1.0 Introduction

- 1.1 This technical note (TN03) has been prepared in response to West Sussex County Council's (WSCC's) further comments on DC/25/0403. WSCC have requested a final tranche of information to be provided to remove their holding objection.

**RE: DC/25/0403 – Full Planning Application – Stonehouse Farm Handcross Road
Plummers Plain West Sussex RH13 6NZ**

Title:
Lot 8
Drainage Strategy

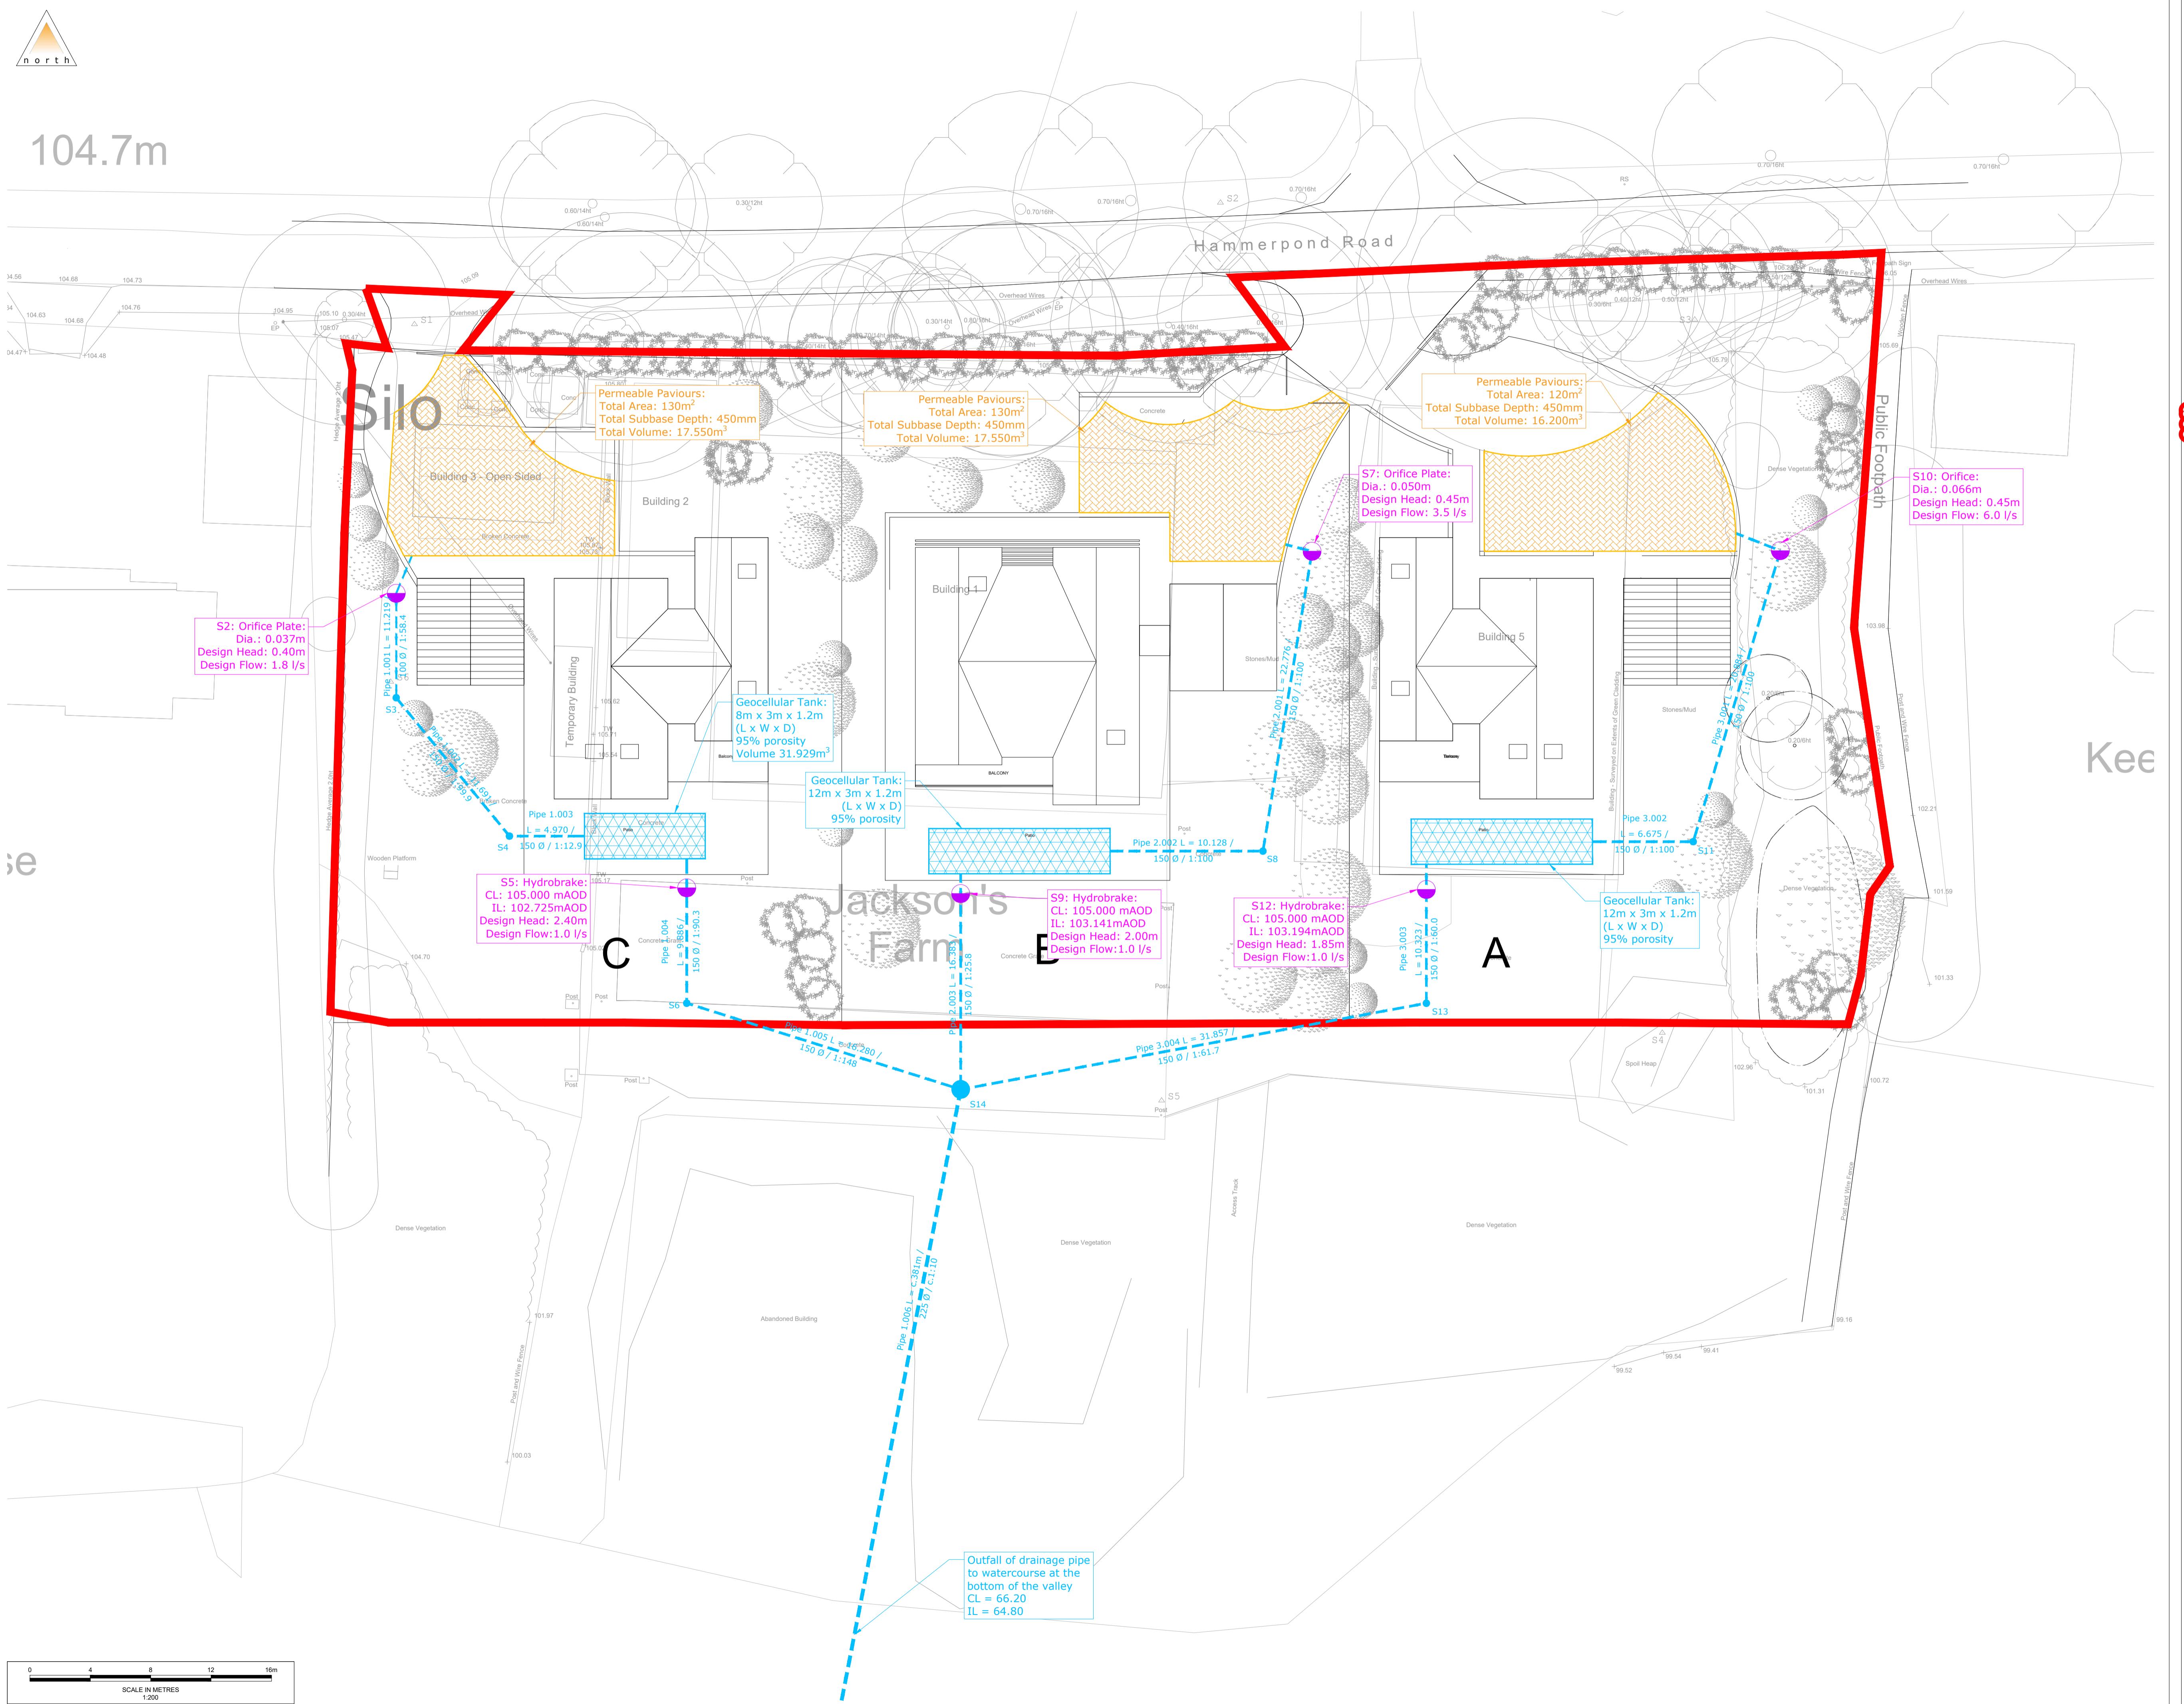
1. *The Applicant has advised they will be using a fully lined system, which is acceptable to address this point however we will require updated technical drawings with notes confirming this.*

The Applicant has advised they will be using a fully lined system, which is acceptable to address this point however we will require updated technical drawings with notes confirming this.

The Applicant has advised they will be using a fully lined system, which is acceptable to address this point however we will require updated technical drawings with notes confirming this
- 2.2 Please see the drawings in [Appendix B](#), all of which contain a note (clouded red) that states "All drainage and SuDS features to be fully lined to prevent groundwater ingress"

- All drainage and SuDS features to be fully lined to prevent groundwater ingress.
